## ANN ARBOR HISTORIC DISTRICT COMMISSION

### Staff Report

**ADDRESS:** 1223 Traver St, Application Number HDC26-0026

**APPLICATION:** The applicant seeks HDC approval to pave a concrete driveway.

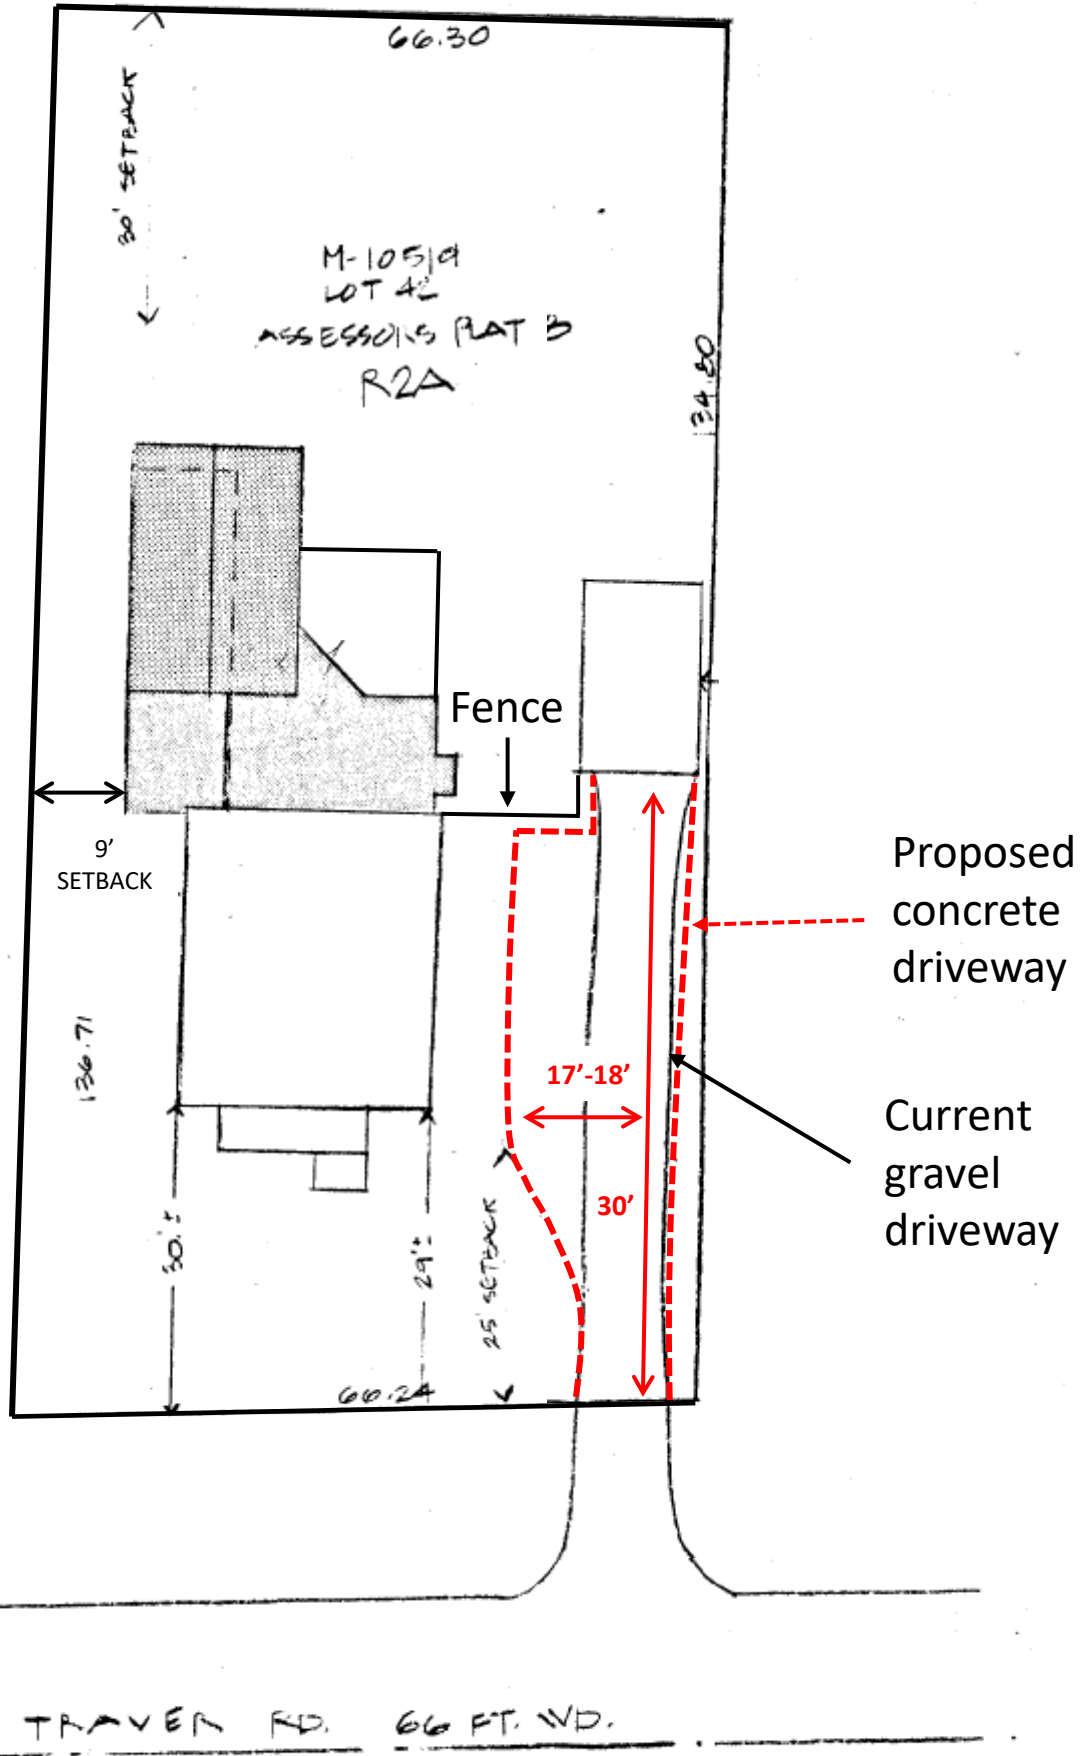
1. The applicant proposes paving an existing gravel driveway to the north of the house. It will align with the existing curb cut on Traver Street.
2. The paved driveway will measure 30 ft east-west, from the right of way to the existing garage. It will be approximately 10 ft wide near the right of way. Then it will expand to approximately 18 ft at the widest and after that will narrow to fit the width of the garage. The paving will be concrete.
3. The proposed driveway will not abut the house. At the closest (the widest point of the driveway), the driveway will be located 4-5 ft from the house. The space between the house and the proposed driveway will have landscaping.
4. Staff recommends approval of the application. The location is appropriate, the paving will not directly abut the house, and the work is reversible.

I move that the Commission issue a certificate of appropriateness for the application at 1223 Traver Street, a contributing property in the Broadway Historic District, to pave a driveway as proposed. The work is compatible in exterior design, arrangement, texture, material and relationship to the surrounding resources and meets the *Ann Arbor Historic District Guidelines* for paved areas and landscape features, and *The Secretary of the Interior's Standards for Rehabilitation*, in particular standards 1, 2, and 10, and the guidelines for building site.
